Memoranda

Date:	– May 19, 2014
From:	 Dr. Carl Bolster, Agricultural Research Service, U.S. Department of Agriculture, Bowling Green, KY
	 Dr. Lee J. Florea, P.G., Department of Geological Sciences, Ball State University, Muncie, IN
	 Dr. Martin J. Shipitalo, Agricultural Research Service, U.S. Department of Agriculture, Ames, IA
	 Mr. Mark Rice, Department of Biological and Agricultural Engineering, North Carolina State University, Raleigh, NC
To:	 Dr. Mark J. Cochran, Vice President for Agriculture, University of Arkansas, Little Rock, AR
Re:	 Report from Expert Panel – C&H Farms Research Project

Response to the Expert Panel Review of the BCRET Project

Figure 1. Plan of possible site of seepage monitoring trench.

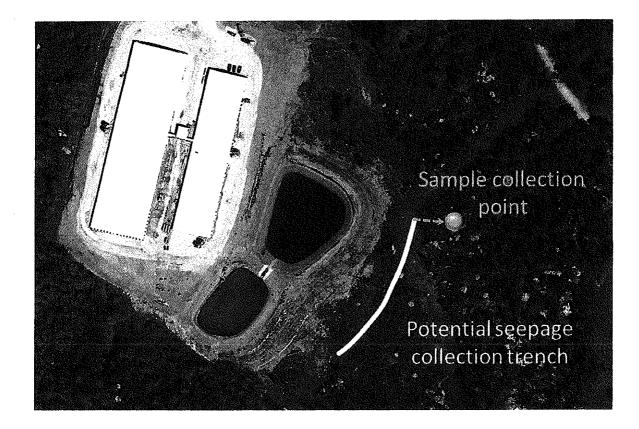
Potential leakage from the waste storage ponds. Currently a single surface water monitoring station is positioned down gradient from the ponds that is capable of sampling intermittent flow events. This should be kept in place. In addition, water usage is being measured in the confinement buildings. The Panel recommends that a short-term, detailed water balance study be conducted to determine the actual seepage rate of the storage ponds. This more robust approach would include a measure of all liquid inputs to the ponds, withdrawals from the ponds, the liquid levels of the ponds and evaporative losses. The results would allow for the calculation of actual seepage rate (within certain bounds) from the storage ponds for comparison to design specifications and standards. In addition, a total water balance approach will identify other potential losses of liquid in excess of that which can be attributable to evaporation and planned withdrawals, either for land application or barn flushing.

Team members should conduct a detailed walking survey of the slope down gradient from the waste ponds to identify potential seeps and springs from perched aquifers. These have some potential for impact by leakage from the ponds. If perched aquifers are noted based on the driller's log or by the identification of hillside seeps, one or more shallow monitoring wells should be installed to the depth of the perched aquifer within as short a distance as feasible from the storage ponds. If springs or seeps are noted on the hillside, these should be monitored on a routine basis to establish baselines and trends in water quality.

- A. Potential Leakage from the Waste Storage Ponds: We agree that the potential for leakage of manure from the storage ponds needs to be closely monitored. To address this we will install a trench downslope of the storage ponds that will intercept any subsurface flow of leakage moving along a restricting or less permeable layer. See Figure 1 for site plans. Initial soil coring reveals a natural cherty layer about 48 inches deep in the profile. Digging a trench below this depth will enable more precise characterization of this, and any other relevant low-permeability features. Once identified, a metal plate will be positioned on the profile just below the preferential flow layer to ensure water is intercepted and collected in a perforated pipe, taking flow to a downslope sampling point. Depending on site conditions, it is envisaged that this trench will be approximately 30' to 40' long and 6' deep. The perforated pipe will be embedded in pea-sized gravel and the top foot of the trench backfilled with soil. This trench collection system has been widely used to monitor shallow subsurface flows in karst systems and USGS have successfully installed one locally in the past to monitor leakage from a swine lagoon. We feel this approach is more technically rigorous to detect and collect seepage than installing single-point wells downslope of the waste storage ponds. Installation will be complete by the end of July. An inventory of karst seeps or springs immediately down slope of the storage ponds will be conducted. These karst features represent natural emergence points where integration of flow occurs and will offer additional sampling points for detecting potential leakage.

Figure 2. Soil P distribution of the 0 to 4 inch depth for Field 1, 5, and 12 on the C&H Farm operation Mt. Judea, Newton County, AR.

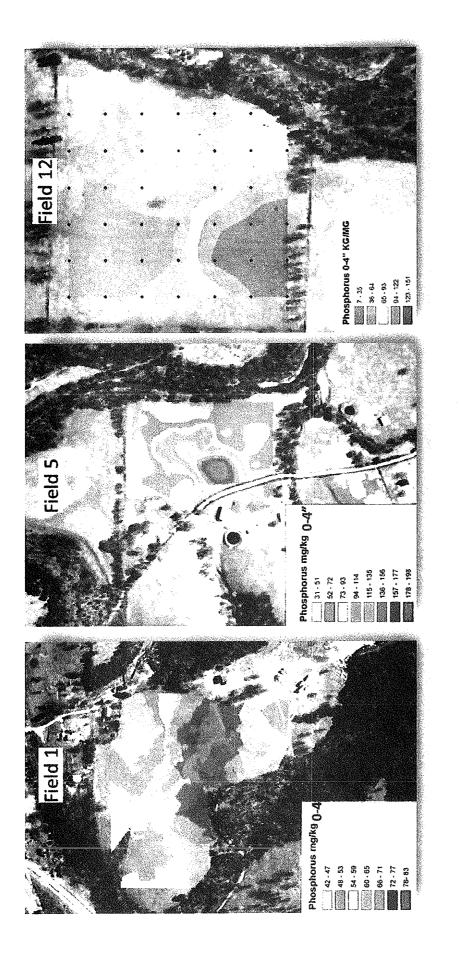
Nutrient buildup. Detailed soil sampling has been conducted on a grid basis to characterize available soil P levels in the monitored manure application fields. This has provided useful information and should be repeated post-manure application. If buildup of soil P levels is noted, the results of the manure solids and liquid separation trials that are being conducted as part of the project may offer an opportunity to better match waste applications to specific crop and soil fertility needs. In general, the manure solids will have a lower N:P ratio than the liquid fraction. Ideally, the dryer solid fraction could be applied to fields where soil P levels are low or transported out of the watershed altogether. In light of C&H Farm's use of additives to enhance the function of the waste storage ponds, a regular sampling of storage ponds is important to understand the effects of the additives and to determine variability in nutrient concentrations.

- F. Nutrient Buildup: The detailed grid-soil sampling (0.25 acre grid) will be conducted annually in late fall or early winter for each monitored permitted field (i.e., Fields 1, 5a, and 12).
